Illinois Tollway Standard Drawing Revisions

Section H Base Sheet Drawings

Standard	Modification Summary	Effective: 2020-03-01
H1	Light Standard Foundation	
	Added new sheet showing single face barrier foundation detail.	
H2	Light Standard Details	
	Removed bolt covers.	
	Callout crimping requirement for fuse holders.	
	Removed unused ground cable.	
	Added compression splice detail.	
H14	Sign Luminaire Mounting Detail and Wiring Diagrams	
	Added note regarding surge protection device.	
H16	Mast Arm Cable Assembly (Twin Mast Arm)	
	Revised mounting bracket detail to show common model.	
	Revised cable routing detail to prevent pinching.	
	Truss type arm shown with revised tag location.	
	Note to route cable outside polyethylene tube.	
	Note to form cable loops with proper orientation.	
	Note to minimize slack within luminaire.	
	Note to install continuous cable.	
H17	Mast Arm Cable Assembly (Single Mast Arm)	
	Revised mounting bracket detail to show common model.	
	Revised cable routing detail to prevent pinching.

LIGHT STANDARD FOUNDATION DETAILS - SINGLE FACE BARRIER

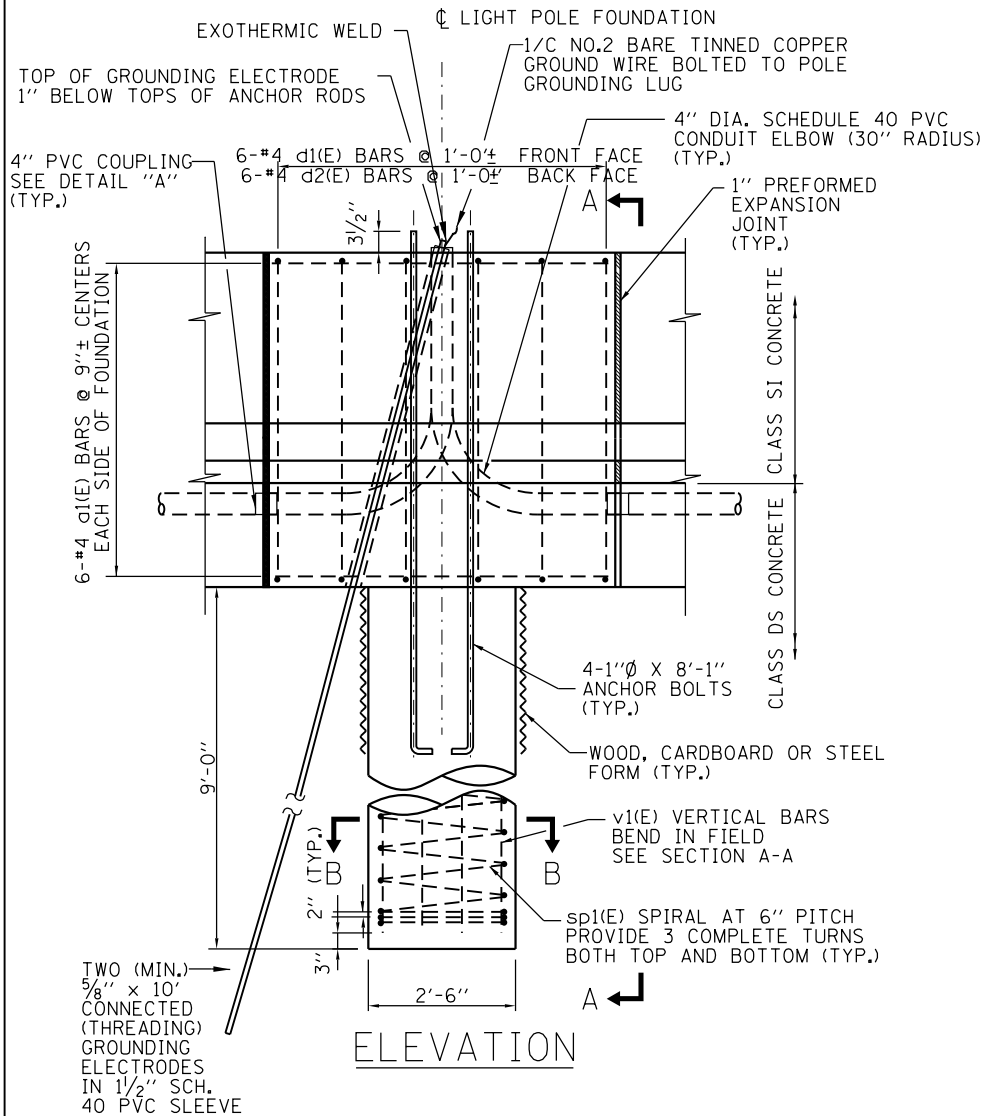
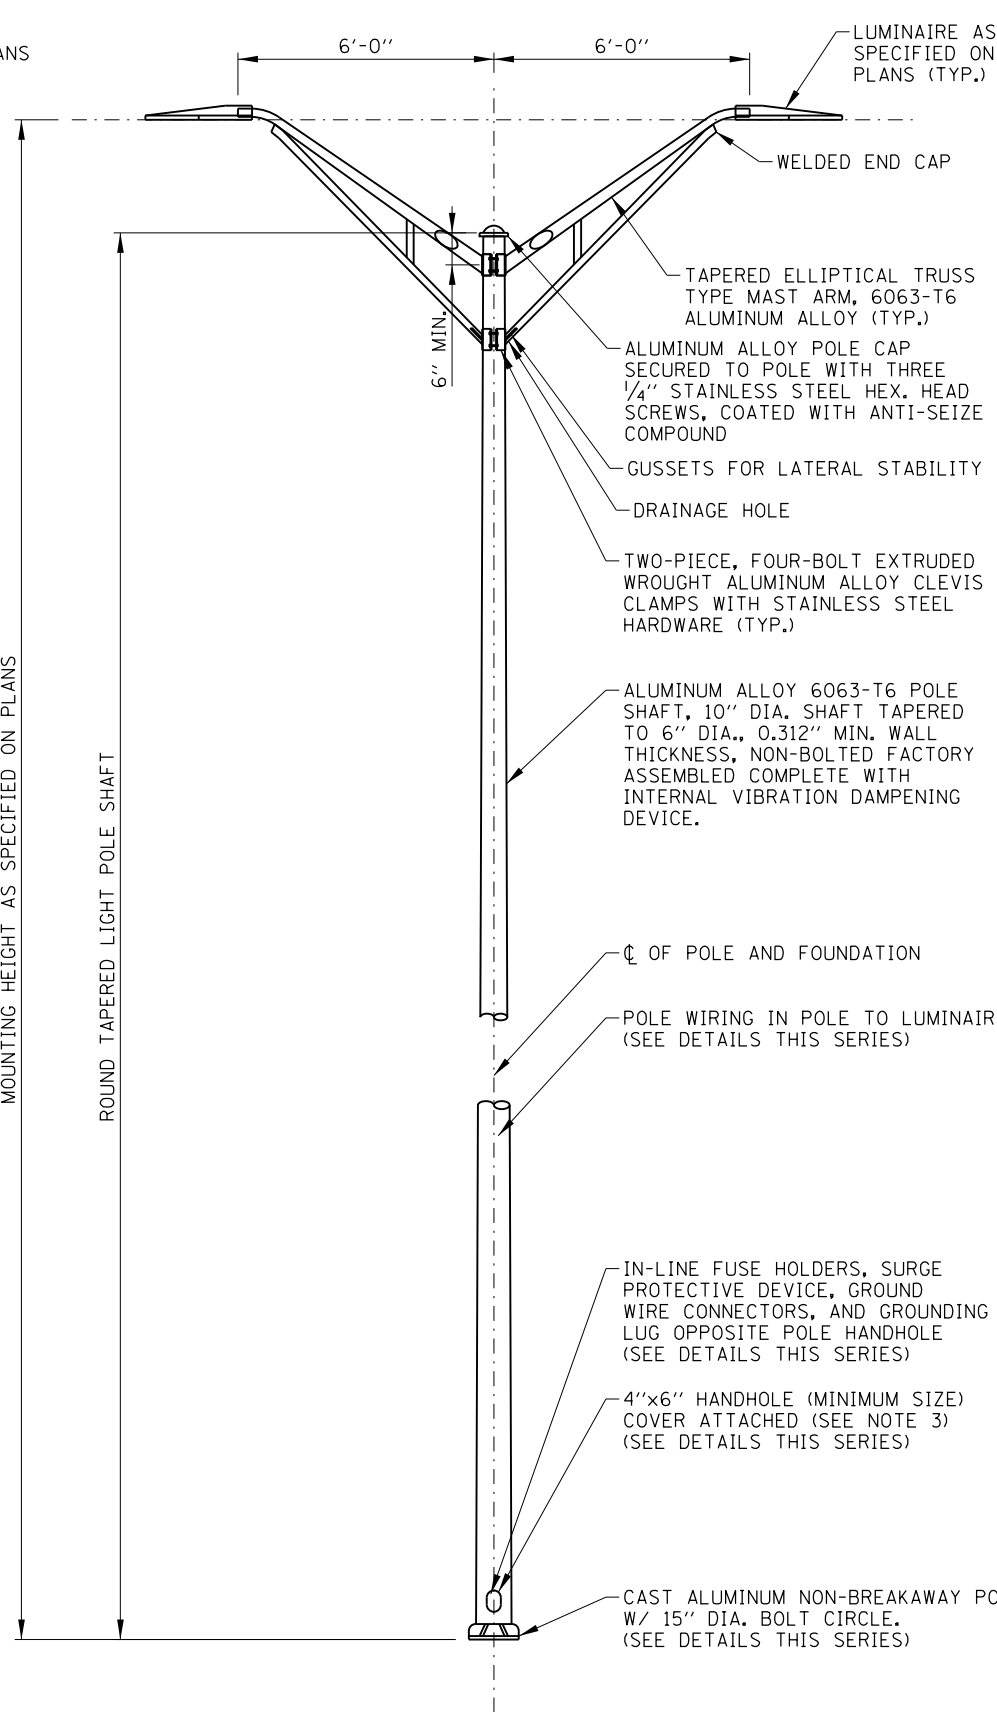
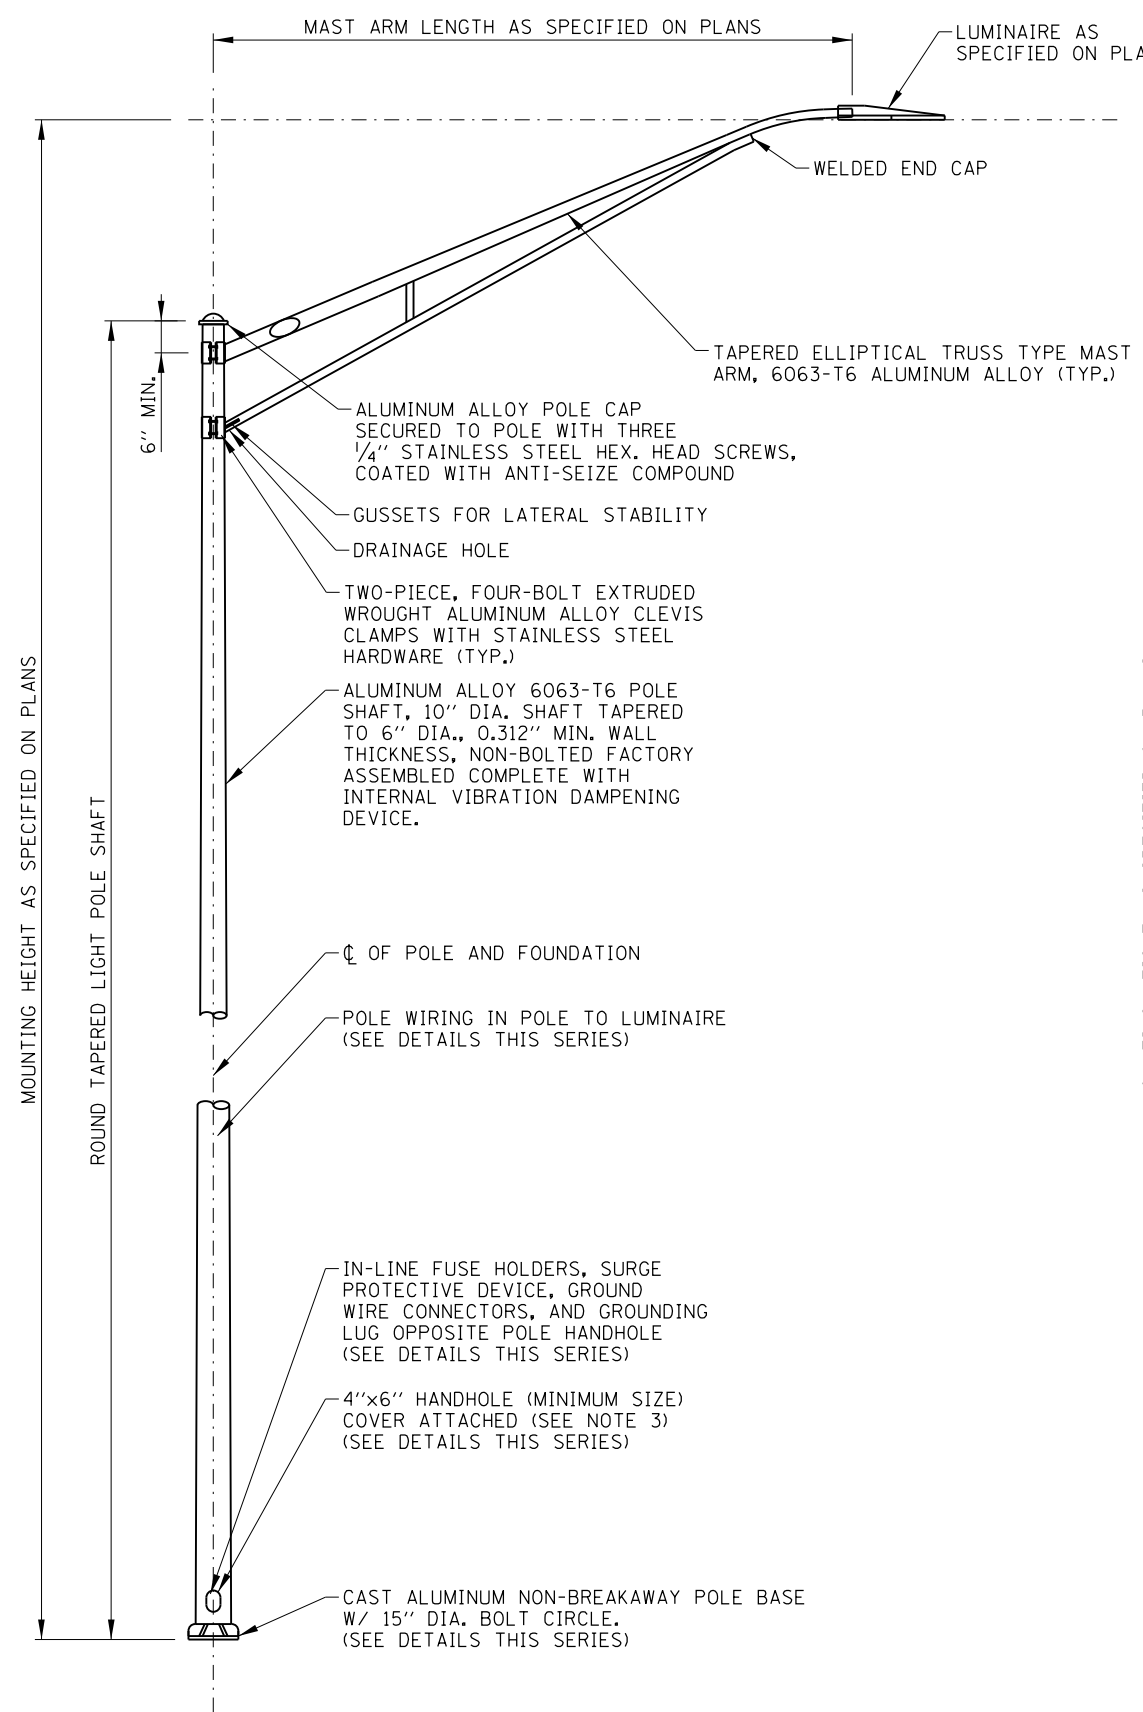
DATE	REVISIONS
3-31-2014	REVISED HELIX FOUNDATION, NEW DETAIL
3-11-2015	"A", AND GRADED AREA MOVED MEDIAN BARRIER MOUNTED FOUNDATION DETAILS.
3-31-2016	REVISED MEDIAN FOUNDATION ANCHOR BOLTS. ADDED HELIX FOUNDATION DEPTH INFORMATION.
3-01-2018	INCREASED POLE SETBACK.
3-01-2019	REVISED CONCRETE BARRIER DETAILS. REDUCED SETTING PLATE SIZE.
3-01-2020	ADDED SINGLE FACE BARRIER DETAIL.

LIGHT STANDARD DETAILS

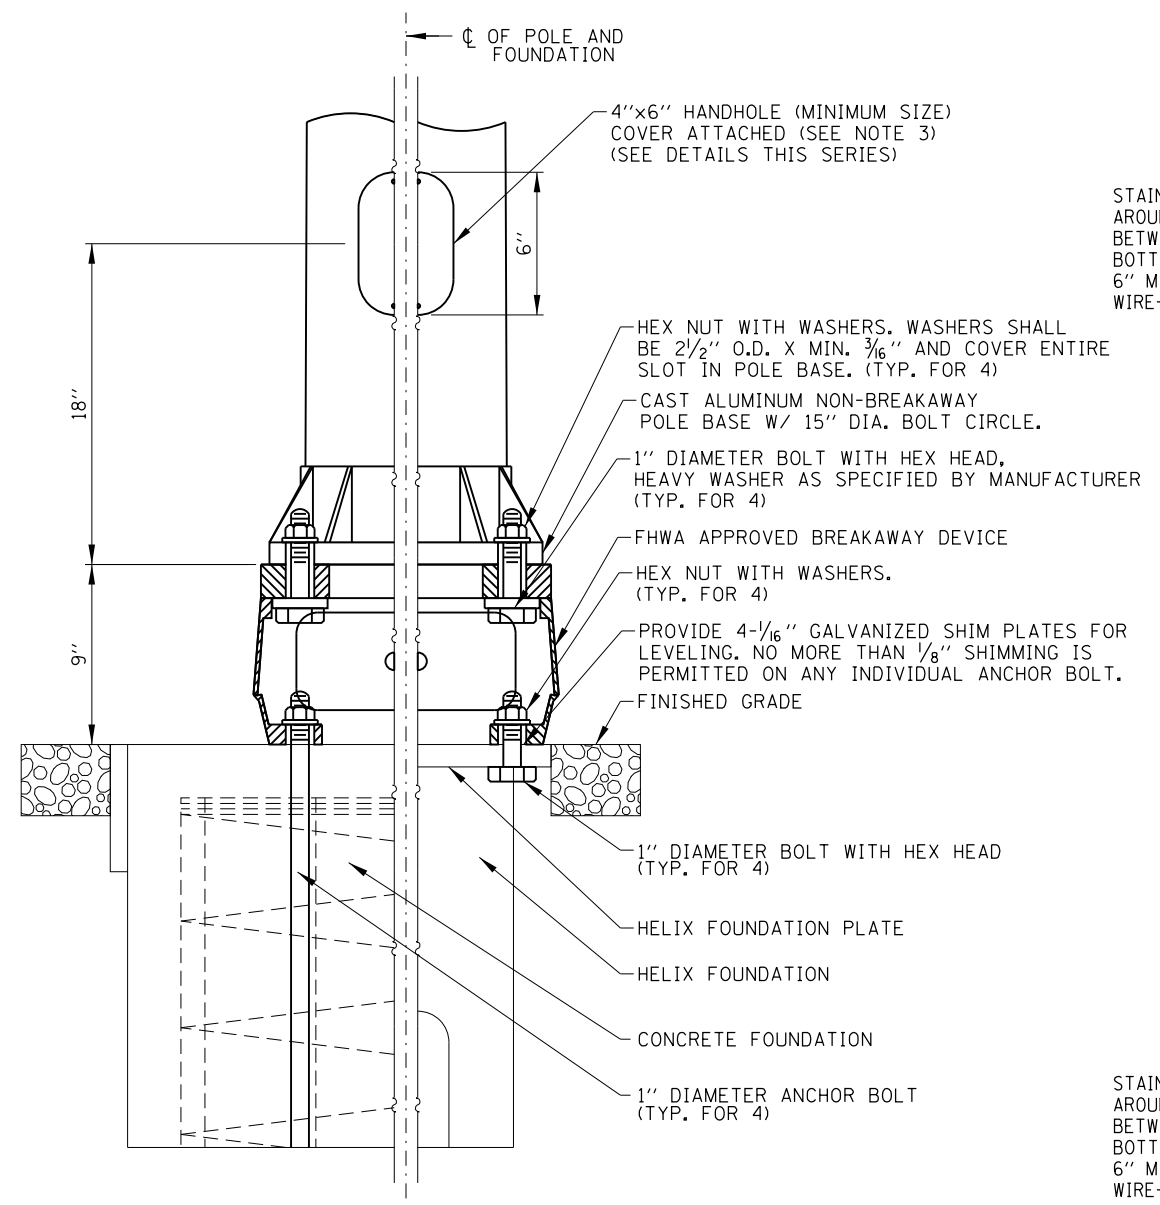
DATE	REVISIONS
3-11-2015	REVISED LIGHT STANDARD POLE WIRING DETAILS.
3-31-2016	REVISED BARRIER WALL UNIT MOUNTING DETAILS.
3-31-2017	REVISED LIGHT POLE AND MAST ARM DETAILS.
	REVISED WIRING DETAILS: GROUNDING & SPLICES.
3-01-2018	REVISED LIGHT POLE AND MAST ARM DETAILS.
3-01-2019	REVISED LIGHT POLE AND MAST ARM DETAILS.
3-01-2020	REMOVED BOLT COVERS.

**LIGHT STANDARD - TRUSS ARM
(TWIN TRUSS ARM SHOWN, TWIN MAST ARM SIMILAR)**

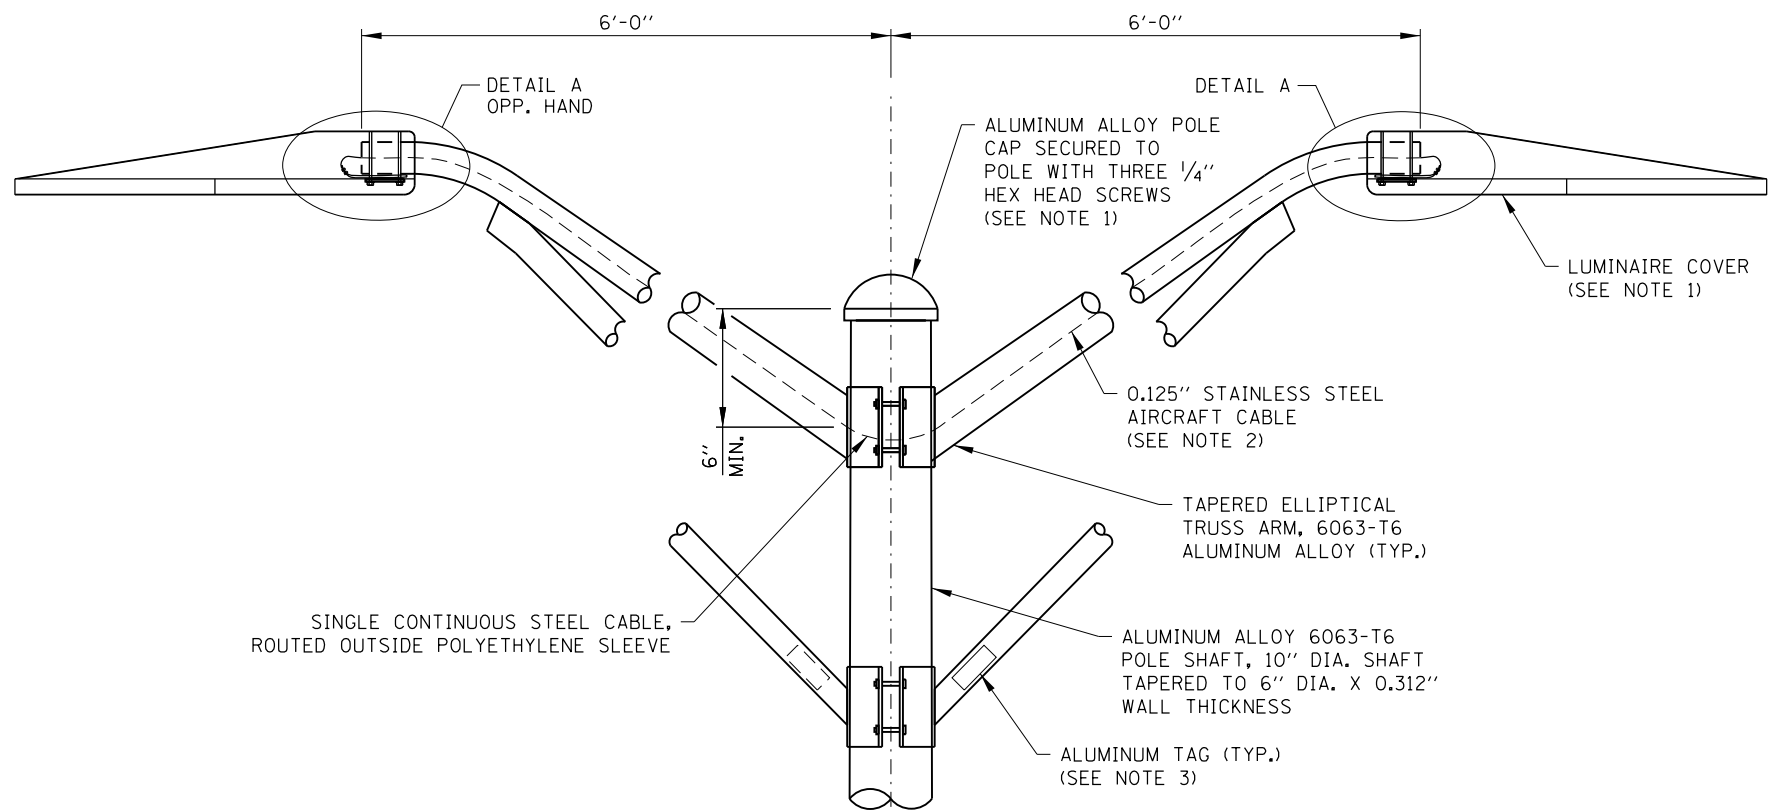
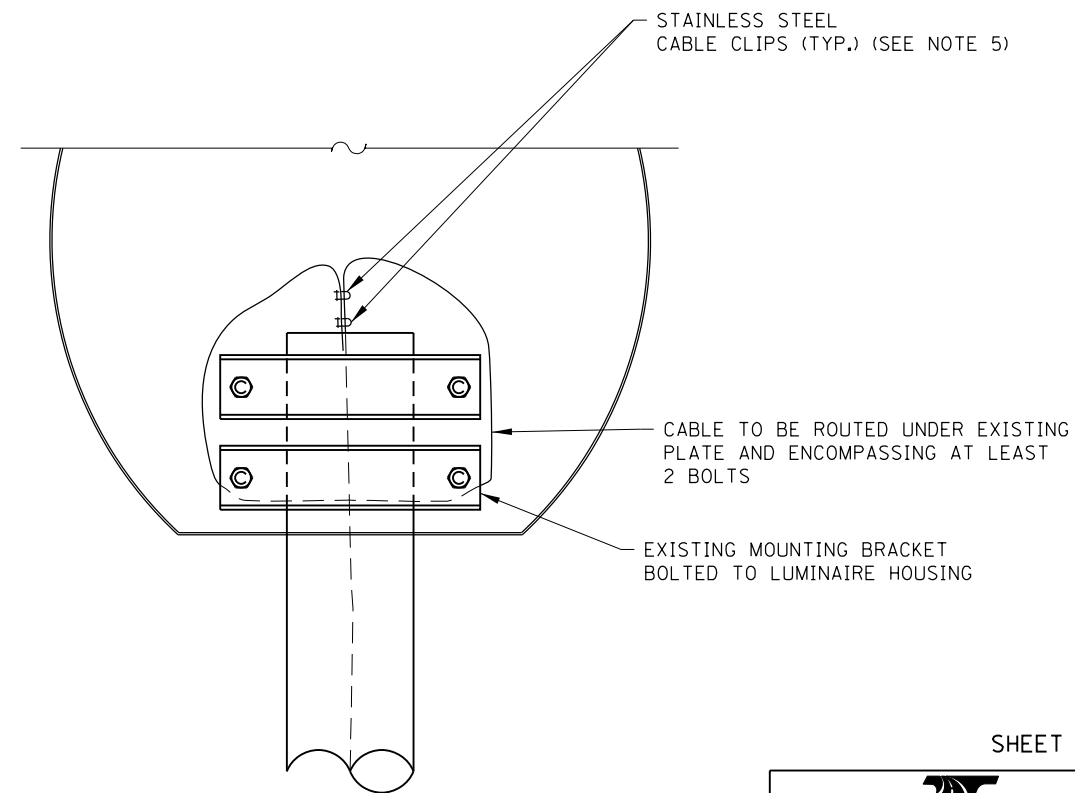
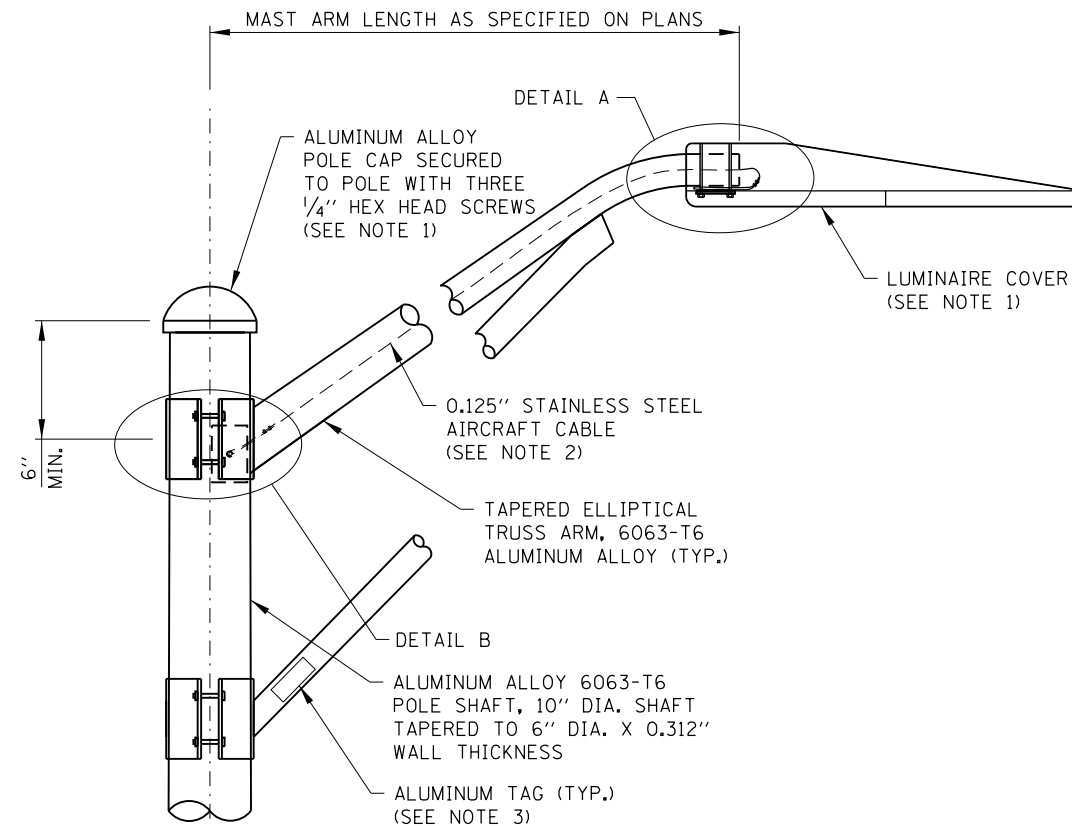
Truss type arm shown with revised tag location.	
	Note to route cable outside polyethylene tube.	
	Note to form cable loops with proper orientation.	
	Note to minimize slack within luminaire.	
	Enlarged detail of steel plate attachment.

DATE	REVISIONS
3-01-2020	REVISED BRACKET AND ROUTING DETAILS.

LIGHT STANDARD - TRUSS ARM
 (SINGLE TRUSS ARM SHOWN, SINGLE MAST ARM SIMILAR)

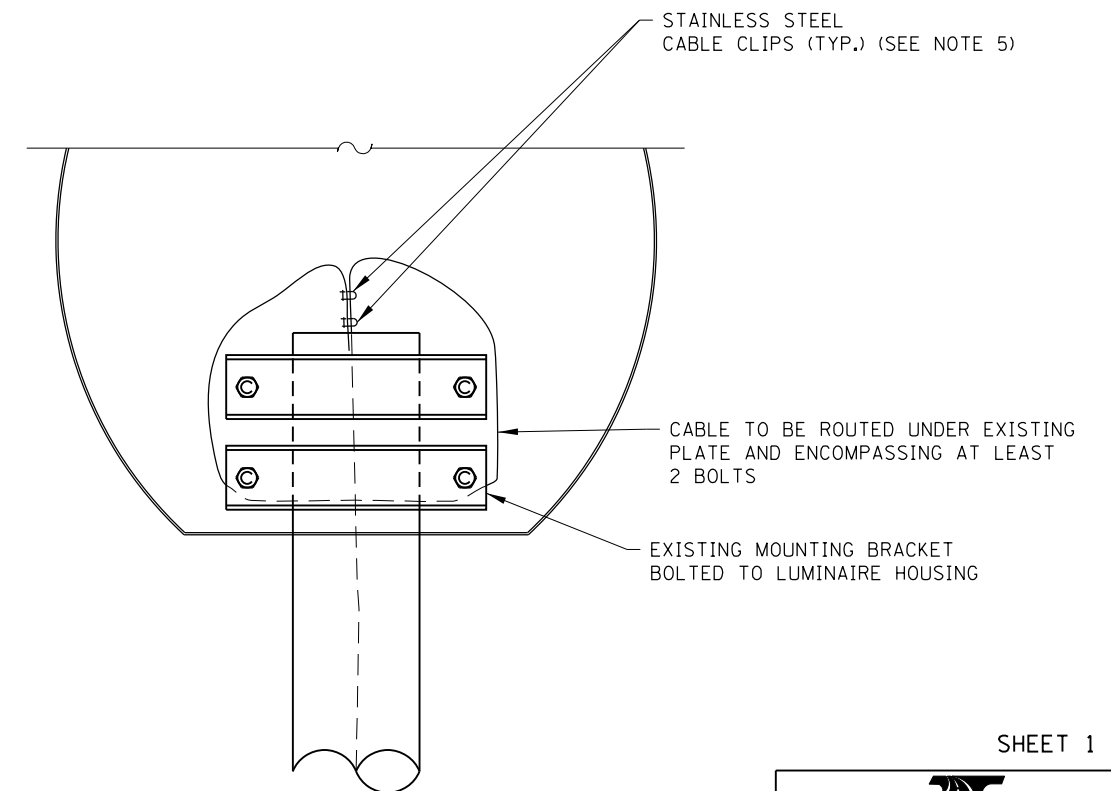
DATE	REVISIONS
3-01-2020	REVISED BRACKET AND ROUTING DETAILS.
